Trigas DM

Alicat-3-MFC Mixing Block

99-00035-000

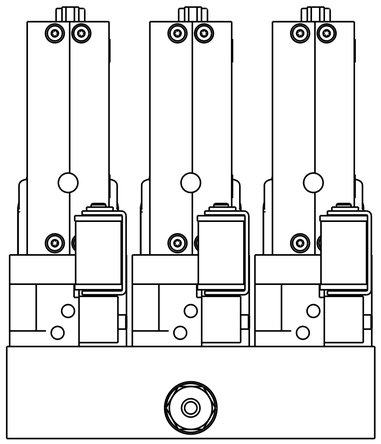
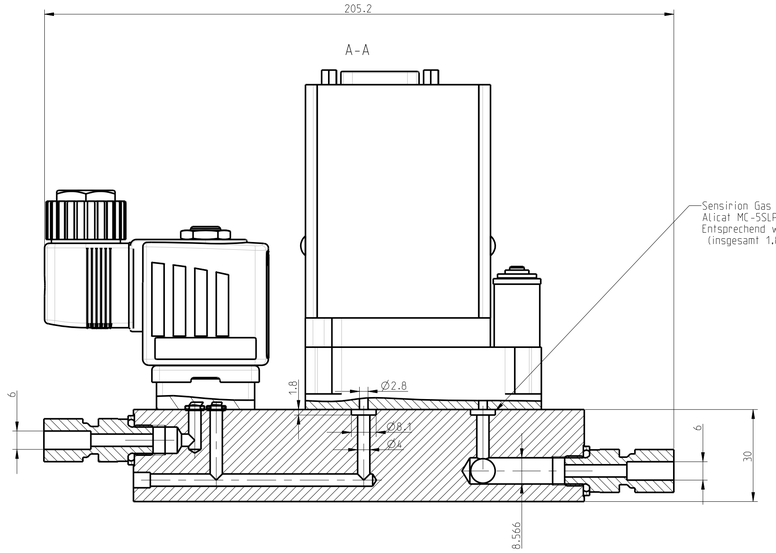
Sensirion Gas Flow SFC4000 hatten AD 1,3 mm Vertiefungen für O-Ringe
Alicat MC-5SLPM-NESSI hat keine Vertiefungen!
Entsprechend wird die Vertiefung auf der Plattenseite um 1.3 tiefer
(insgesamt 1.8 mm) um O-Ring AD 8. T=2 mm einzusetzen.

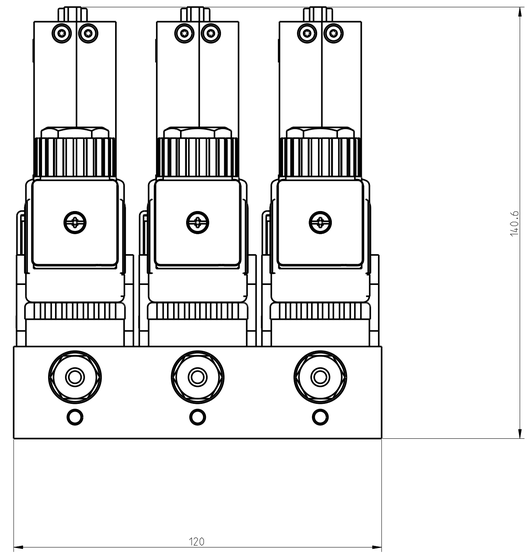
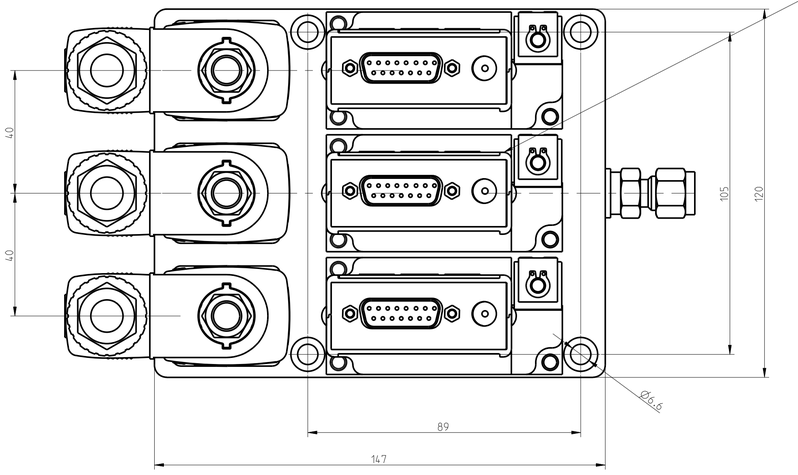
Nicht jeder Display ist zu sehen, weil die sehr nach zusammenstehen
